REQUEST

Current Zoning: R-3 (single family residential)
Proposed Zoning: B-2(CD) (general business, conditional)

Approximately 10.44 acres located on the west side of Reames Road, south of West W.T. Harris Boulevard.
(Council District 2 - Harlow)

The petition proposes to allow up to 29,600 square feet of commercial uses (including retail with fuel sales), a hotel with up to 125 rooms, and dedication of land for greenway purposes on a site located south of Northlake Mall.

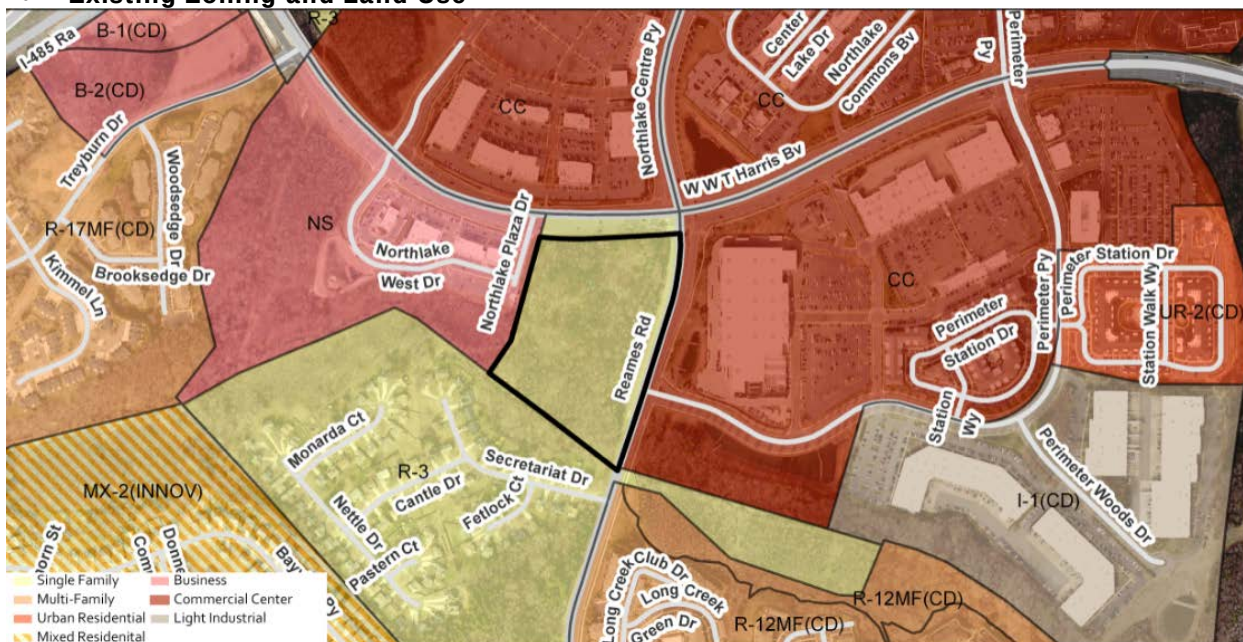
Proposes the following transportation improvements:

- Intersection of W.T. Harris Boulevard and Reames Road:
 - Restripe existing eastbound W.T. Harris Boulevard right turn lane to a shared through/right lane extending to Northlake Plaza Drive.

- Intersection of West W.T. Harris Boulevard and Northlake Plaza Drive:
 - Restripe the existing eastbound West W.T. Harris Boulevard right turn lane to a shared through/right lane.

- Intersection of Reames Road and Access A:
 - Construct a southbound Reames Road right turn lane.
 - Construct Access A with one egress and one ingress lane.

- Intersection of Reames Road and Perimeter Parkway/Access B:
 - Construct Access B with one egress and one ingress lane.
 - Construct a concrete median to restrict access to right-in/right-out/left-over.

- Construct a pedestrian refuge to maintain access.
 - Construct a northbound left turn lane.
 - Remark the southbound through drop lane as a right turn drop lane.

- Installation of a traffic signal.

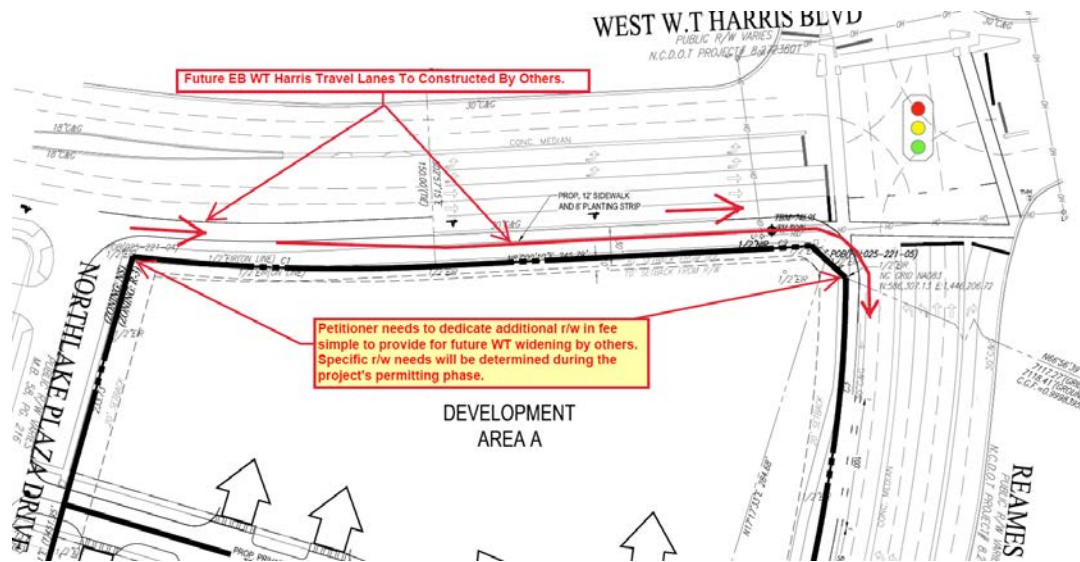
1. West W.T. Harris Boulevard's future widening plans calls for an additional through lane (12-foot width), including a separate 150' eastbound exclusive right-turn lane (12-foot width) with an appropriate bay taper length at Reames Road, and the area plan recommends a 20-foot planting strip and 8-foot sidewalk to support the walkability adjacent to this major arterial in the activity center along the site's WT Harris Boulevard frontage. The petition should revise the site plan to provide 32-foot of right-of-way (where the future thru and exclusive right turn lane coexists) as measure from the existing back-of-curb along the site's West W.T. Harris Boulevard frontage. (See exhibit below).
